# North Carolina Building Code Council

November 18, 2020

RE: Agenda for the December 8, 2020 NC Building Code Council Meeting

FIGURE R4603.6(d)  
CORNER PILE CONNECTION

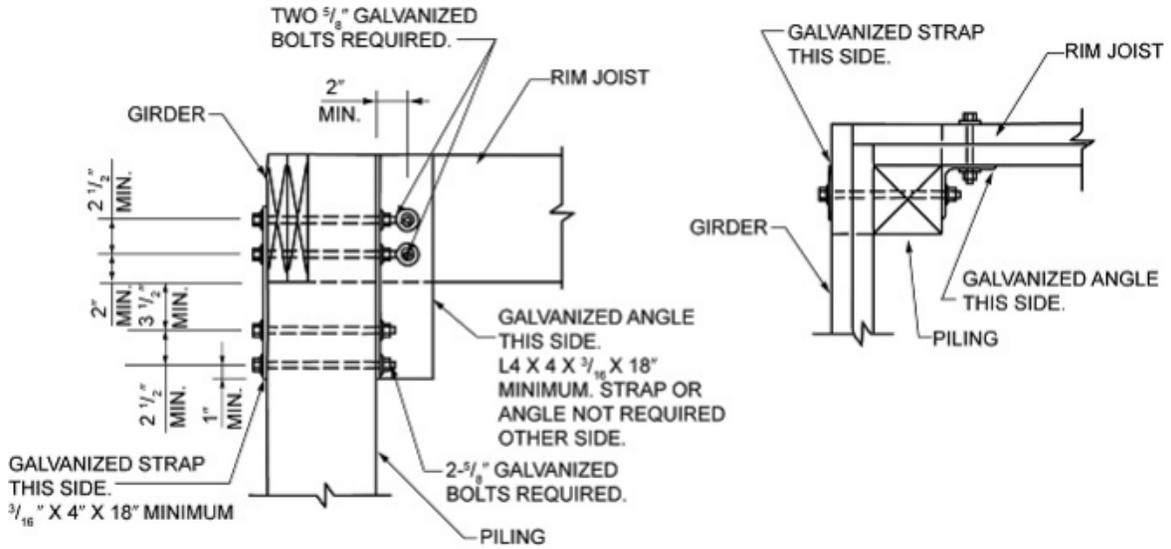
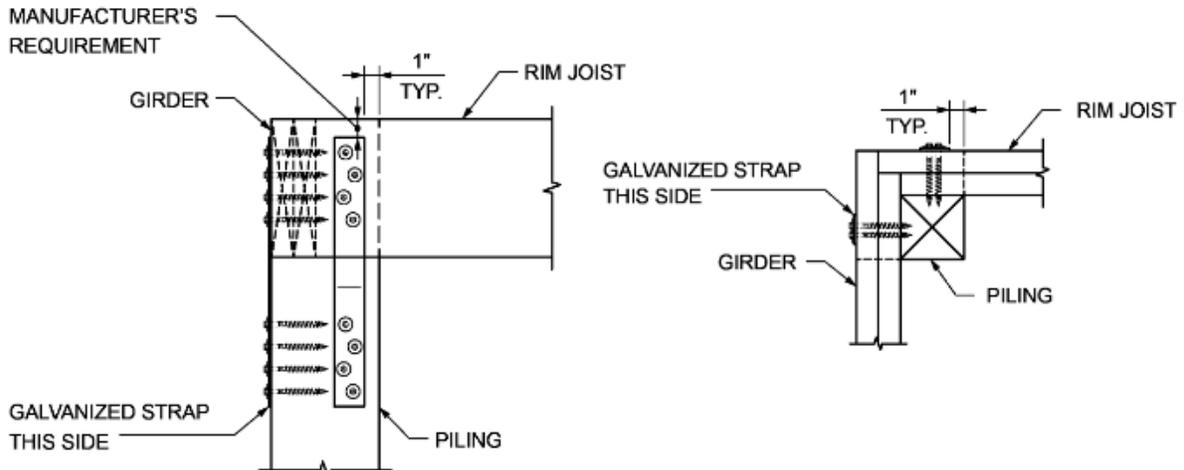
**R4603.6.1 Tying at corners.** At corners, girders shall be connected to the pile with a minimum 3/16 × 4 × 18-inch (5 × 102 × 467 mm) hot dip galvanized strap bolted with two 5/8 inch (15.9 mm) galvanized through bolts on the exterior and a minimum L4 x 3/16 x 1'-6" (102 × 5 × 467 mm) galvanized steel angle bolted with two 5/8 inch (15.9 mm) galvanized through bolts on the interior in accordance with Figure R4603.6(d1), or with a minimum of (2) 3/16" x 4" x 18" (5x102x467 mm) hot dip galvanized straps installed on the outside of the girders with fasteners per table R4603.6.1 and in accordance with Figure R4603.6 (d2).

<u>Amount Piling is Notched</u>	<u>Associated Figure</u>	<u>Hardware</u>	<u>Fasteners</u>
<u>&gt; 50%<sup>1</sup></u>	<u>R4603.6(d)</u>	<u>one 3/16"x4"x18"</u>	<u>six 5/8" bolts<sup>2</sup></u>
		<u>one L4x3/16x18"</u>	
	<u>R4603.6 (e)</u>	<u>one 3/16"x4"x18"</u>	<u>eight 0.27"x4" each<sup>3</sup></u>

FIGURE R4603.6(e)

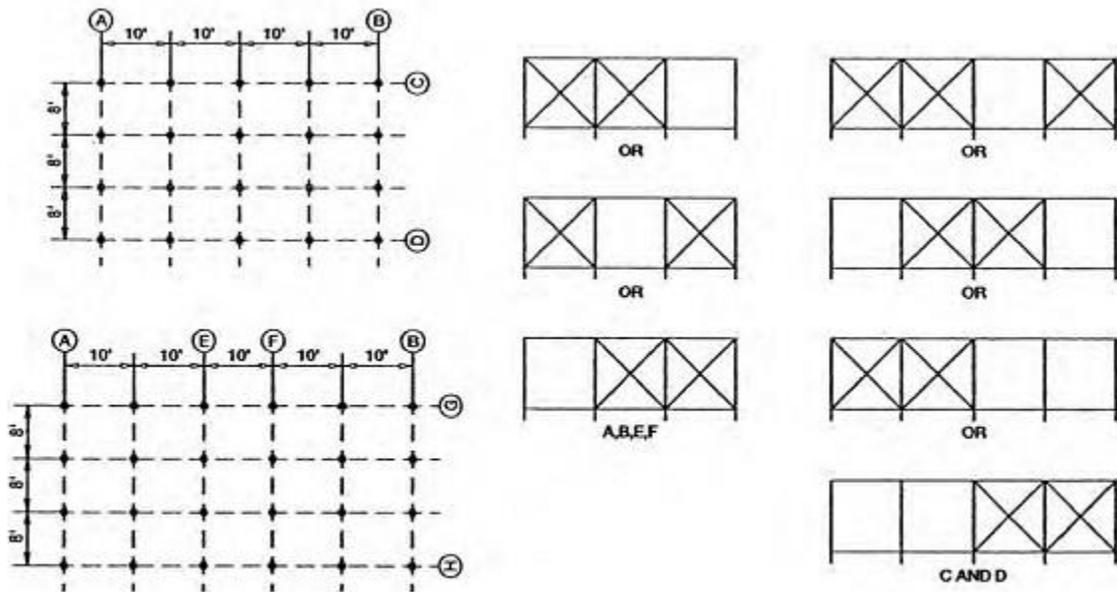
**R4603.6.2 Bracing of Pilings.** Bracing of pile foundations is required where the clear height from ground to sill, beam or girder exceeds 10 feet (3048 mm) or the dwelling is more than one story above piles. A line of X-bracing is defined as a row of piles with X-bracing provided in at least two bays. A line of X-bracing shall be provided at all exterior pile lines. Where the perimeter lines of X-bracing exceed 40 feet (12 192 mm), an additional line of X-bracing shall be provided near the center of the building. See Figure R4603.6(e)(f). X-bracing shall be with 2 × 10s through bolted with two 3/4-inch (19.1 mm) bolts at each end. The code official is

permitted to accept alternate bracing designs if they bear the seal of a registered design professional.
